PRAIRIE ISLAND NUCLEAR GENERATING PLANT
Docket Nos. 50-282 License Nos. DPR-42
50-306 DPR-60

Pressure and Temperature Profiles Outside Containment

ANSWERS TO THE QUESTIONNAIRE (SEE ATTACHMENT)
PRESSURE & TEMPERATURE PROFILES OUTSIDE CONTAINMENT
FOR
PRAIRIE ISLAND UNIT 1 & 2

FIG. 1 ZONE SV COMPARTMENT CONFIGURATION FOR A DOUBLE ENDED MAIN STEAM LINE BREAK IN Y COMPARTMENT

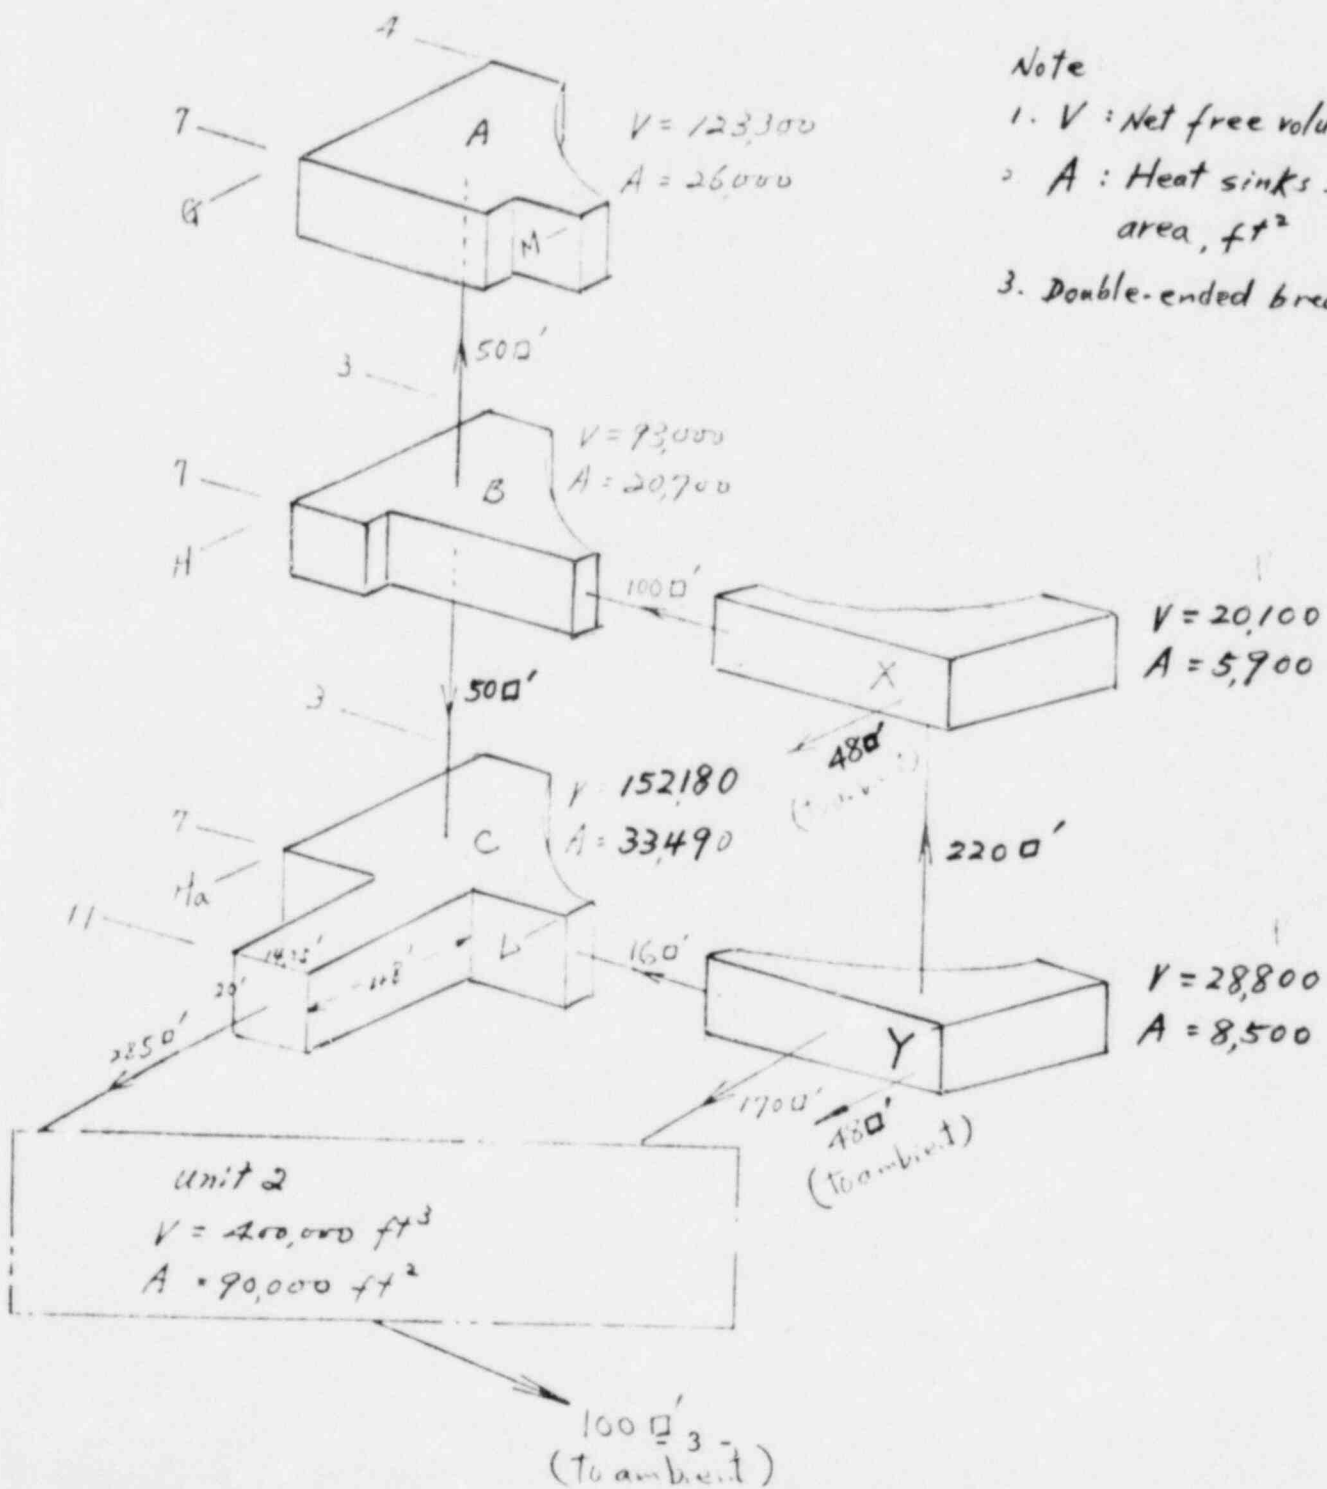
1. With respect to the pipe to be broken, provide the following:
 - a. Type of fluid (water or steam);
 - b. Temperature;
 - c. Pressure;
 - d. Source of the fluid;
 - e. Flow rate (or assumed flow rate);
 - f. Pipe internal diameter;
 - g. Wetted perimeter of the break (feet);
 - h. Total pipe internal diameter;
 - i. Exit flow area, if the break was not in the pipe, just described above;
 - j. Area of flow restriction, if any;
 - k. Differential elevation from the source to the pipe break;
 - l. Total flow resistance (only if the fluid is water);
 - m. Means to stop fluid flow (none, gate valve, globe valve, etc.); and
 - n. If item l.m above is a valve, then the valve's open throat area, full open flow coefficient, valve closure time, and delay time until initiation of valve closure.

2. With respect to the compartments being analyzed, provide the following:
 - a. Number of compartment analyzed; and
 - b. For each compartment:
 - i. initial temperature
 - ii. initial pressure
 - iii. initial humidity
 - iv. free air volume (cubic feet)
 - v. number of vents and vent areas (square feet) for each vent; and
 - vi. minimum pressure to initiate flow to the next compartment (psia).

1. A double-ended main steam line rupture in Category I Zone compartment Y (Fig. 1).
 - a. Steam
 - b. 547⁰F
 - c. 1020 psia
 - d. Saturated steam from the steam generator at hot standby conditions.
 - e. Assuming that $f1/D = 0$ and a discharge coefficient of one, the mass velocity from the Moody's correlation is 2100 lbm/sec ft². With an effective flow area of 7.16 in², the steam flow rate is 1044.17 lb/sec.
 - f. Steam pipe I.D. = 27.951"
O.D. = 30"

Encapsulation sleeve I.D. = 30.75"
 - g,h,i,j Effective annulus flow area defined by the steam pipe and the encapsulation sleeve is 71.6 in².
 - k. The differential elevation is zero as $f1/D=0$.
 - l. N/A
 - m. None Assumed
 - n. N/A
2. Compartment Data (See Fig. 1)
 - a. Six compartments with venting to outside air.
 - b. Initial conditions for all compartments are 80⁰F, 14.7 psia and 30% relative humidity. The compartment free volume in ft³, vent area in ft² and concrete surface area for passive heat sinks in ft² are shown in Fig. 1. Assuming a time step of 0.002 seconds, the minimum pressure to initiate flow is predicted within the computer code.

FIG. 2 PRESSURE (P_y) AND TEMPERATURE (T_y) TRANSIENT
FOLLOWING A DOUBLE ENDED MAIN STEAM LINE BREAK
IN COMPARTMENT Y.

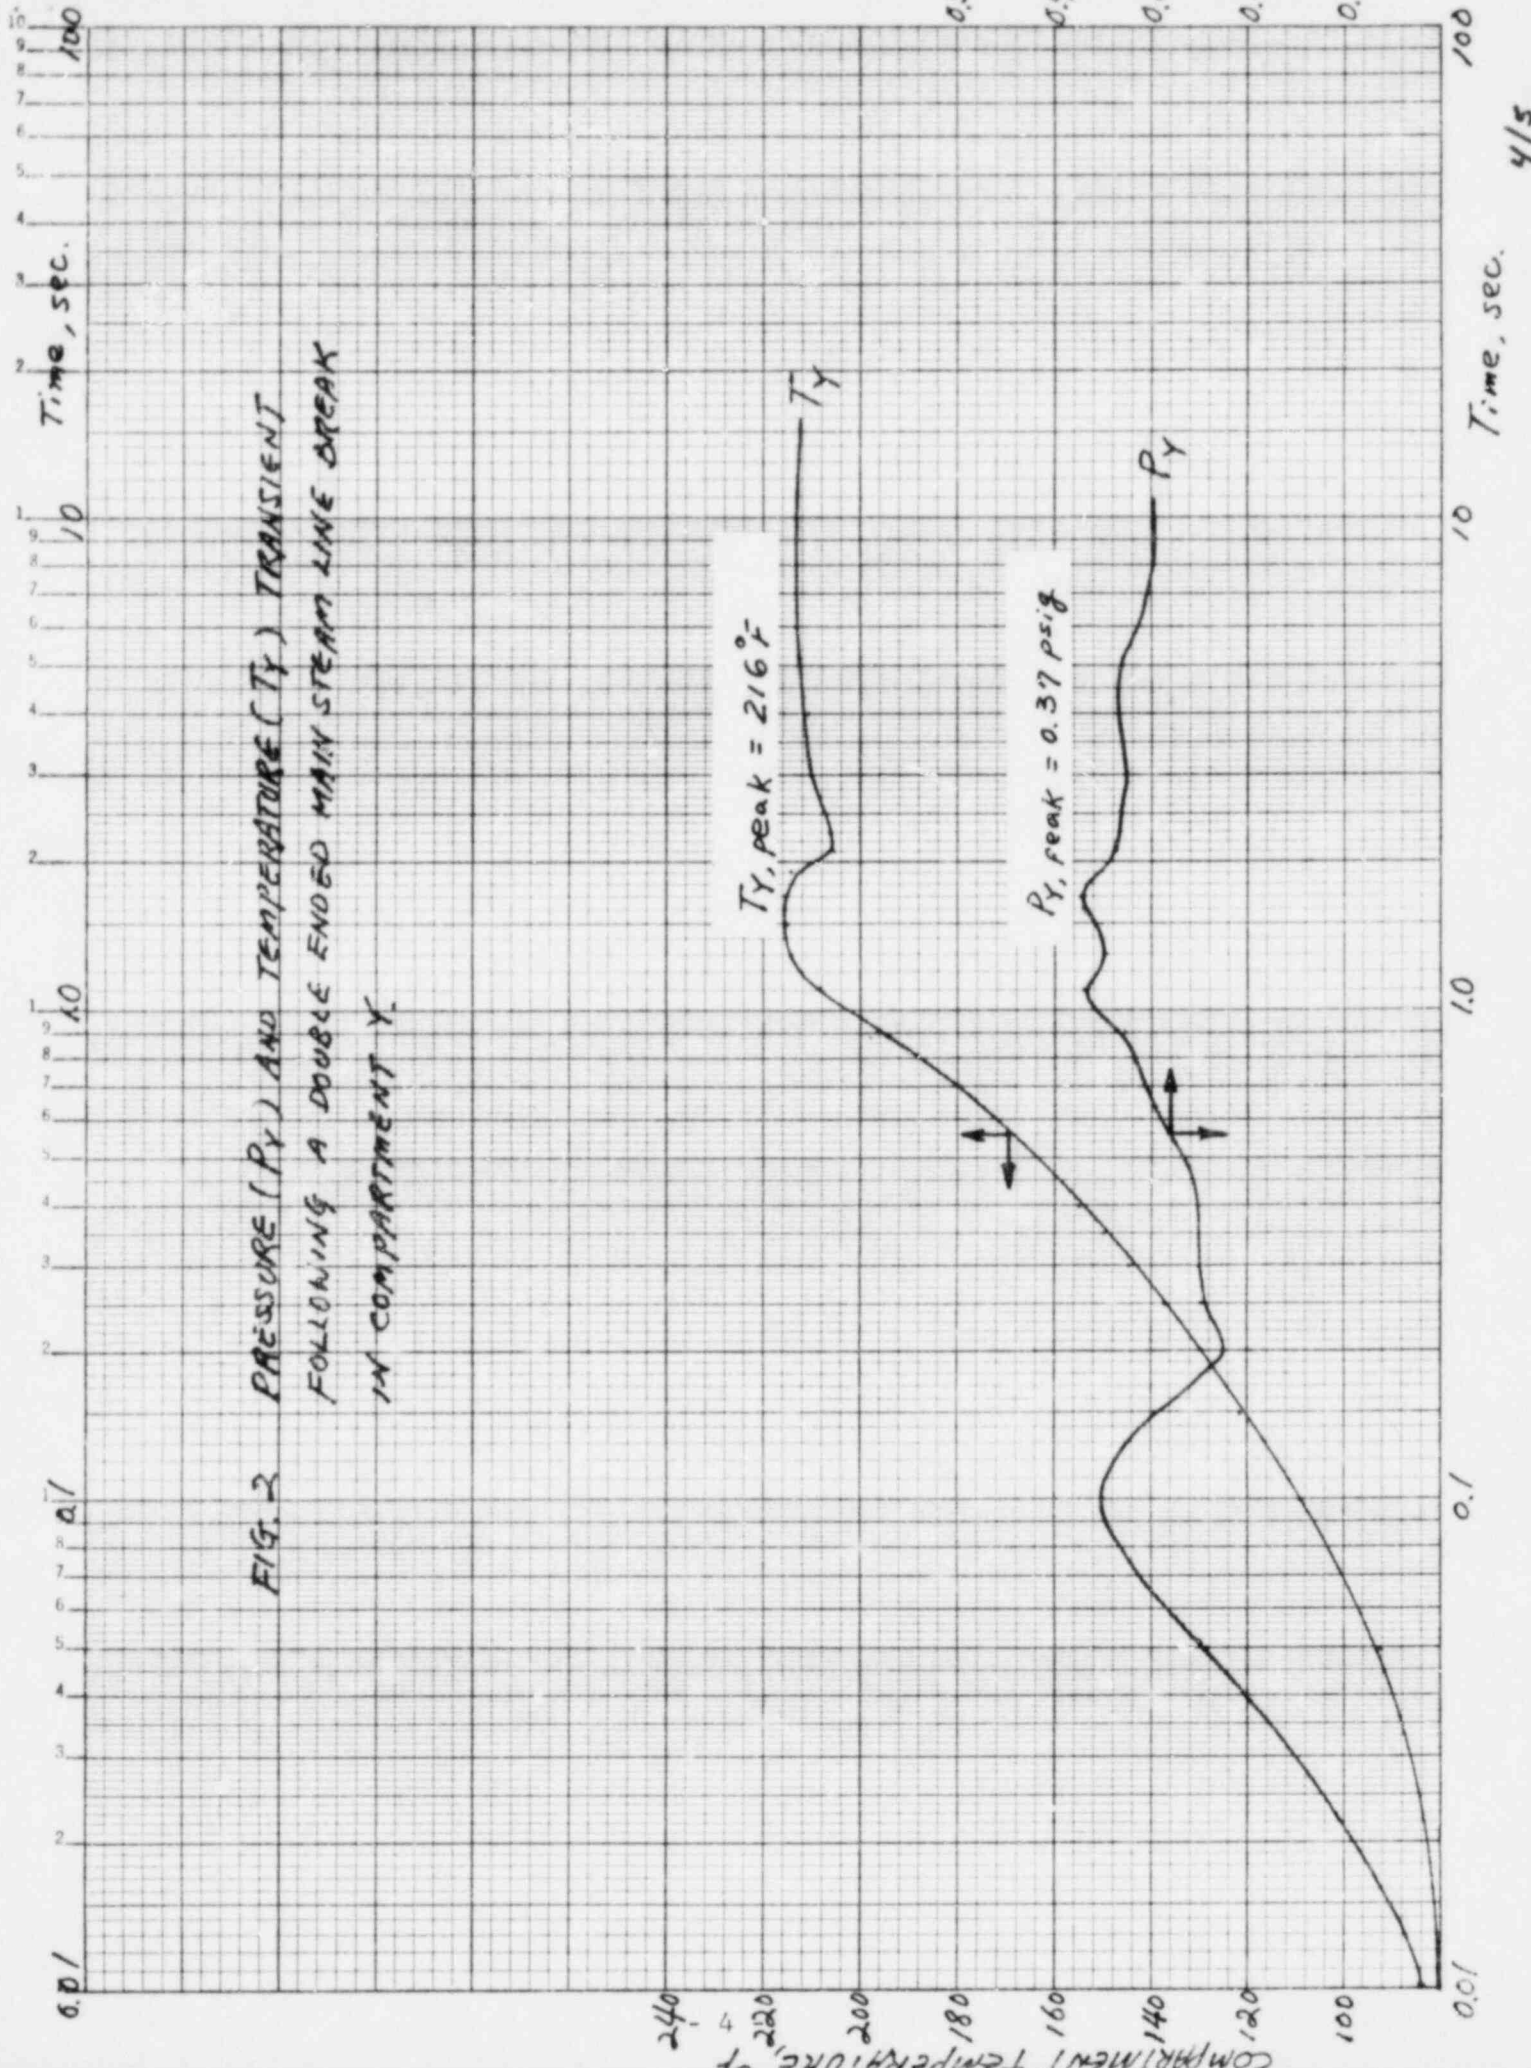
3. Provide all assumptions used, including but not limited to the:
 - a. Orifice coefficient for the "end effects" for the discharged fluid; and
 - b. Fluid expansion factor.

3. The computer code used in predicting the compartment pressure and temperature response to the steam line rupture is the CONTEMPT4/MOD2, a multi-compartment containment system analysis program. Each volume is considered a standard compartment and the method of computing the pressure and temperature response in a standard compartment is similar to the method used in the CONTEMPT-LT program.

- a. All vents (doors & stairways) are considered sharp edged orifice with a flow coefficient of $\Delta p = \frac{2.9v^2}{2g}$
